## **REMARKS**

### **Drawing Correction and Amendments to the Written Description**

The attached sheet of drawings includes a change to Fig. 1. The sheet, which includes Figs. 1-4, replaces the original sheet including Figs. 1-4. In Figure 1, two reference numerals have been revised and a "Prior Art" designation has been added.

**FIG. 1**  
PRIOR ART

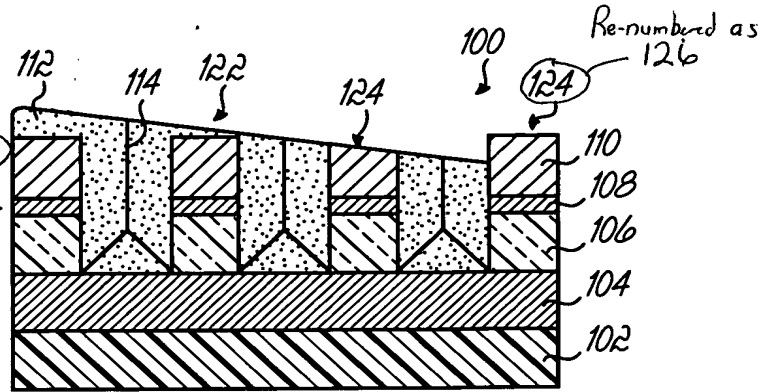
Applicants have amended the drawings to correct minor labeling errors in Fig. 1. In Fig. 1, one occurrence of reference numeral 122 has been revised to read reference numeral 120, one occurrence of reference numeral 124 has been revised to read reference numeral 126, and a "Prior Art" designation has been added. Applicants have also modified the written description so that the description of Fig. 1 more accurately conforms to the drawing of Fig. 1. Applicants submit that no "new matter" has been introduced into the specification by these amendments.

Re-numbered  
as 120
